Memo

To:	John Roberts, PEng	Client:	TMAC Resources Inc.
From:	Gregory Fagerlund, MSc	Project No:	1CT022.002
Reviewed By:	Maritz Rykaart, PhD, PEng	Date:	December 4, 2015
Subject:	Response to NRCAN IR-3 & AANDC IR#13: Estimation of the Time Required for the Underground Mine to Fill

Figure 1: Estimated volume of the mine over time for the Doris Central and Connector Zones

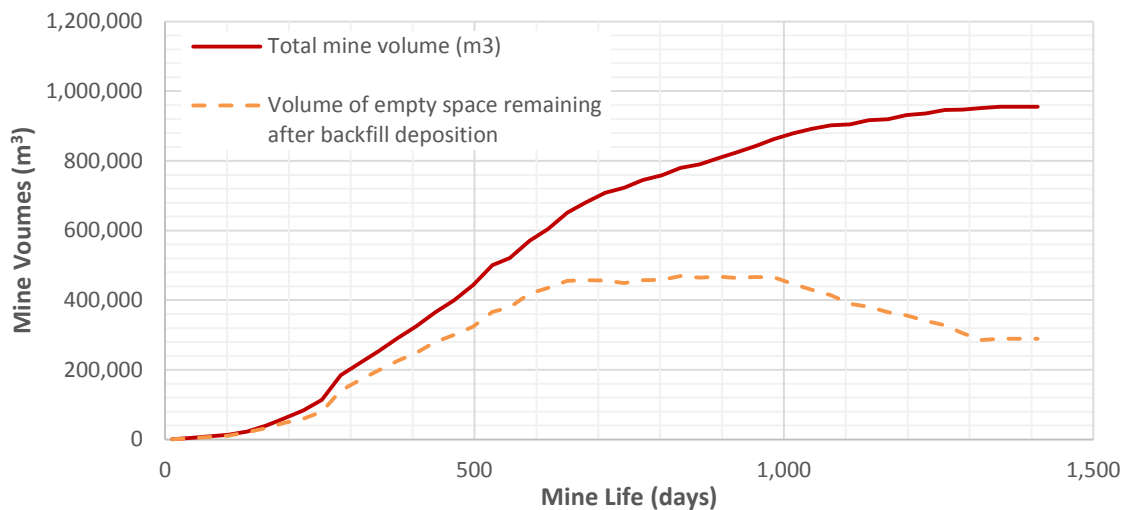
- Please provide clarification on the post-mining groundwater flow regime in the vicinity of the underground mine.
- Please provide information on the time required for the underground mine to fill and clarification on post-mining groundwater regime (flow directions and rates) and potential impacts to the groundwater quality.

Please provide an analysis of the combined impact of detoxified tailings and backfilled PAG waste rock on groundwater.

Once mining at Doris ceases, and the mine workings have been prepared for closure, mine dewatering pumps will be switched off and the mine will reflood. Figure 1 shows a plot of the mine volumes over time for the portions of Doris Central and Connector zones which are below the

elevation of Doris Lake, including both talik and non talik zones, which is the maximum level to which the mine would flood. Two curves are represented: one curve corresponds to the total mine volume and the other, the volume of empty space remaining after backfill is deposited. Figure 2 shows a plot of the predicted inflow versus mine level elevation (in mine grid elevations).

The reflood time was estimated using a simplified step-wise approach that uses the groundwater inflow numerical predictions and the planned volume of mine workings. The time to reflood each mine level was calculated based on inflow rate predictions presented in Document P6-3, Groundwater Inflow and Quality Model at the respective mine levels and the planned mine volumes.
